# **Opel Corsa-D - Front brake system**

**Model year 2007**

**Front brake system**

## **Squeaking noises when braking**

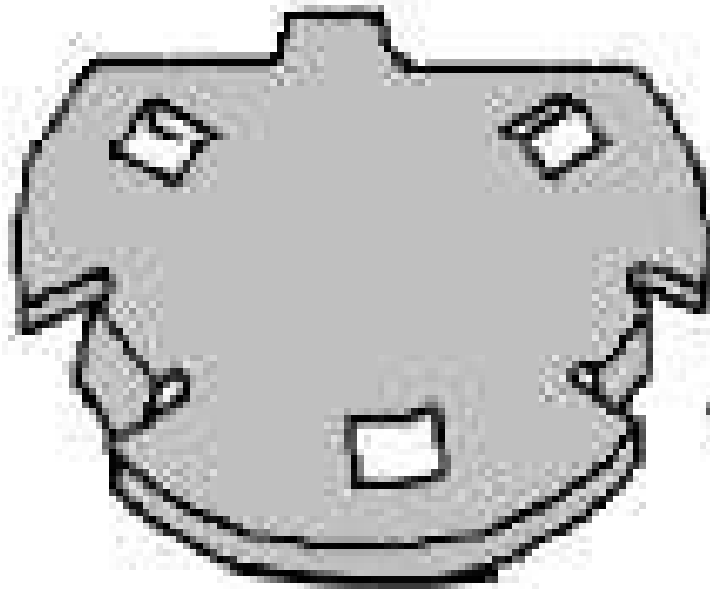
If the symptom specified above cannot be allocated to any detectable defect on the wheel brake, one possible cause of this is an insufficient decoupling between the brake pad and the brake caliper. For improving comfort, the vehicle manufacturers have installed so-called "Piston Caps" in the piston (A) of the brake calipers.

In case of a complaint, this must be checked and renewed where appropriate. On vehicles affected without "Piston Caps", these can be retrofitted.

These additional "Piston Caps" (B) have been introduced to the production from the following chassis numbers.

Eisenach: W0L0SDL0876108784

Zaragossa: W0L0SDL6874284654

Spare part number "Piston Cap": Opel 93169307
